Subject: Western Star ECC Park Brake Output Signals

Models Affected: Specific Western Star 4700, 4900 and 6900 models with Cummins EPA10 engines manufactured May 12, 2010, through January 29, 2013.

Daimler Trucks North America LLC, on behalf of its wholly owned subsidiary, Western Star Trucks Sales, Inc., is initiating Field Service Campaign SF483A to modify the vehicles mentioned above.

June 2013
SF483A

Fig. 1, Brake Supply Air Line and Brake Air Pressure Switch

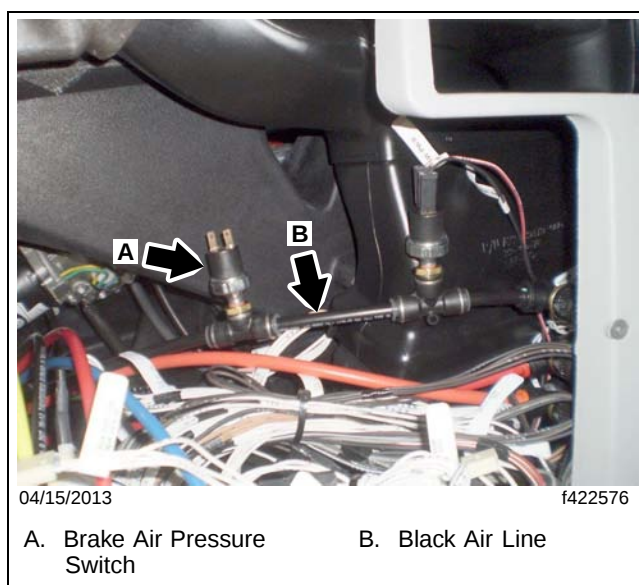
The park brake input signal will be moved from the ECC to an independent air switch.

7. Install the tee and air pressure switch (from the kit) into the park brake supply air line. See **Fig. 1**
 8. Using parts from the kit, attach the terminals and connectors to the ends of the new wires.

9. Connect the new wires to the new park brake air pressure switch.
 10. Route the new wires back along the existing wire loom to the ends of wires 440X and 440G and trim off any excess length.

Fig. 2, ECC Connector

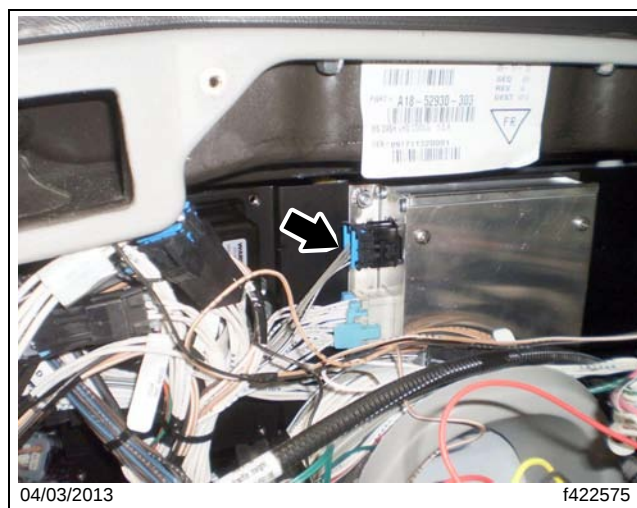
If wires 440X and 440G have not been relocated to a separate switch, and are still connected to the ECC as shown in **Fig. 2**, go to the next step.

11. Remove wires 440X and 440G from the ECC connector pins G and H. See **Fig. 2**.
 12. Remove and discard the existing terminals from the wire ends of 440X and 440G.

13. Using the crimp, solder, and seal Butt connectors (from the kit), connect the new wires from the new park brake air pressure switch to wires 440X and 440G.
